DOCKET NUMBER
PROPOSED RULE **PR-60**
(46 FR 35280)

MEMORANDUM FOR Honorable Nunzio J. Palladino
Chairman
U.S. Nuclear Regulatory Commission
Washington, D.C. 20555

ASSESSMENT OF TECHNICAL CRITERIA OF
10CFR60 FOR GEOLOGIC DISPOSAL OF
HIGH-LEVEL WASTE

Fig. 4 Effect of Different Canister Lifetimes (t_c). Release Rate = 10^{-5} yr^{-1} .

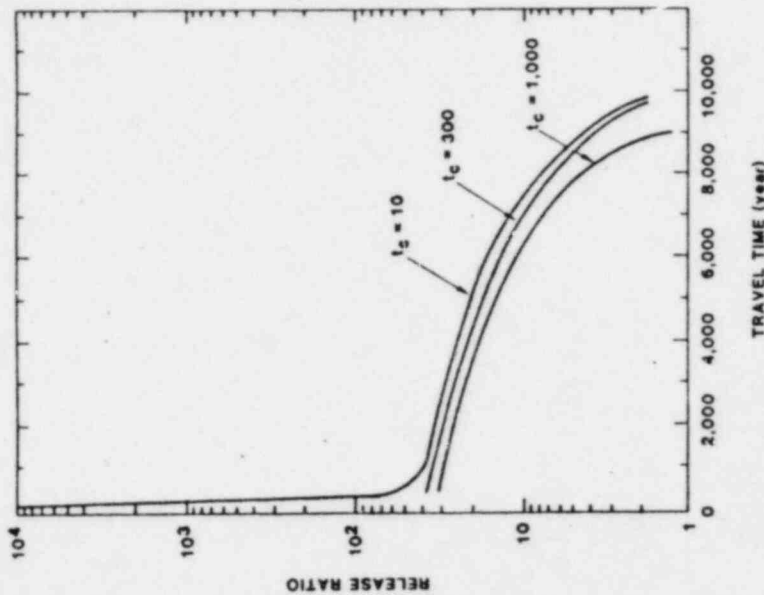
The effect of different canister lifetimes (t_c , years) on the release of nuclides in Group I is shown in Fig. 4. Note that if a constant release rate and a groundwater travel time greater than ~500 years is assumed, then the presence of canister has little effect on releases.
